Spare Feet Unit One

City Plan Commission — February 26, 2026

| CASE NUMBER/TYPE: | SUSU25-00095 – Major Combination |

SUMMARY OF RECOMMENDATION: Staff recommends **PENDING** of Spare Feet Unit One on a Resubdivision Combination basis and **PENDING** of the exception requests. Related to this application, the applicant is requesting the following exceptions from the City Plan Commission:

Figure A: Proposed plat with surrounding area

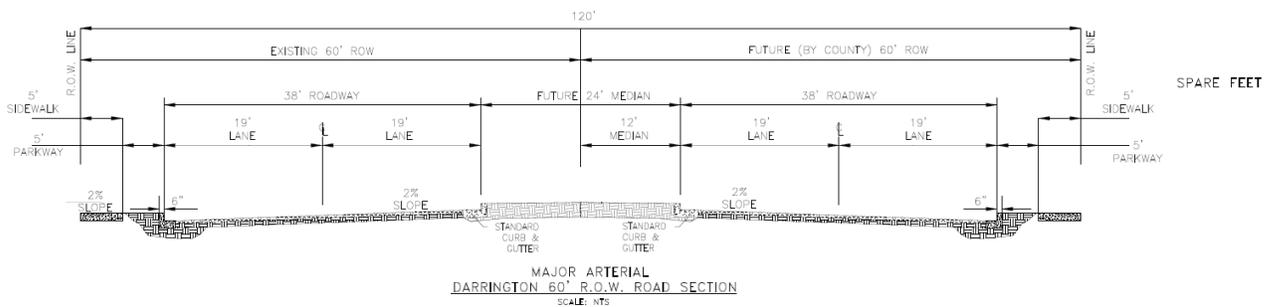
1. To waive the construction of one foot (1') of sidewalk along Darrington Road.
2. To allow Block 1 to have a block perimeter in excess of 2,400 feet.

1. To waive the construction of one foot (1') of sidewalk along Darrington Road.

2. To allow Block 1 to have a block perimeter in excess of 2,400 feet.

Figure B: Developed properties within a quarter mile of proposed subdivision

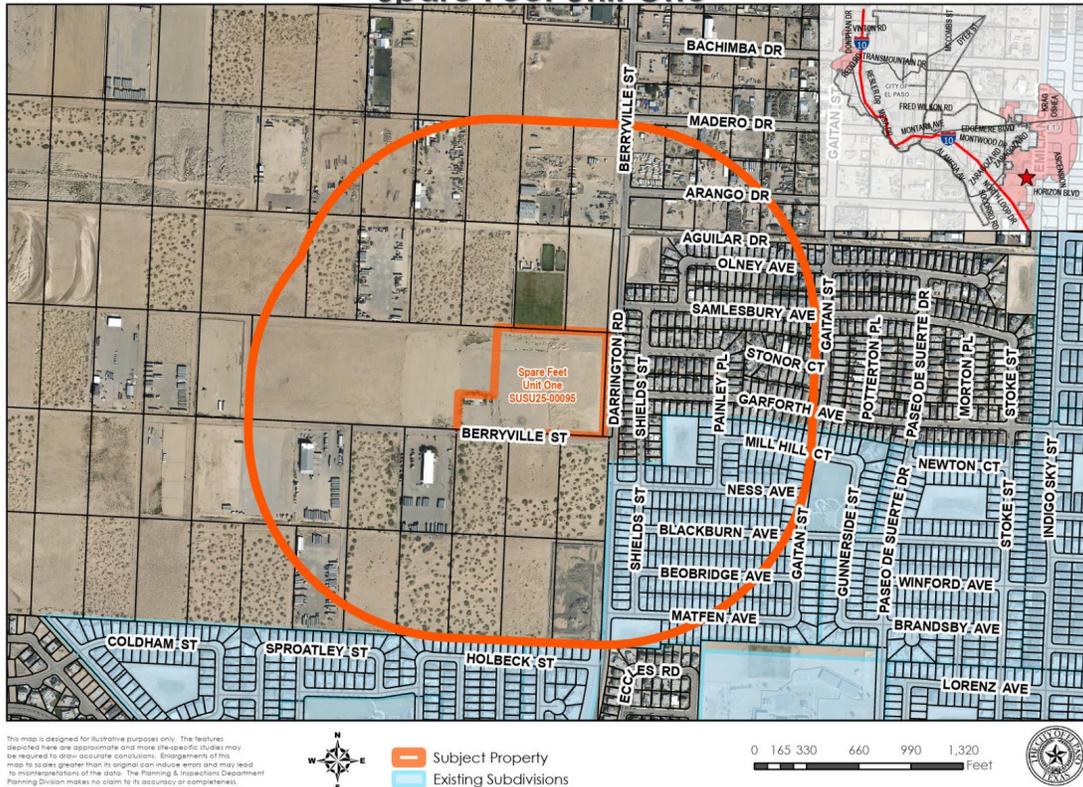
- a: Fifty per cent of the lots within a quarter mile of the proposed development have already been developed and the existing street improvements are in character with the neighborhood.
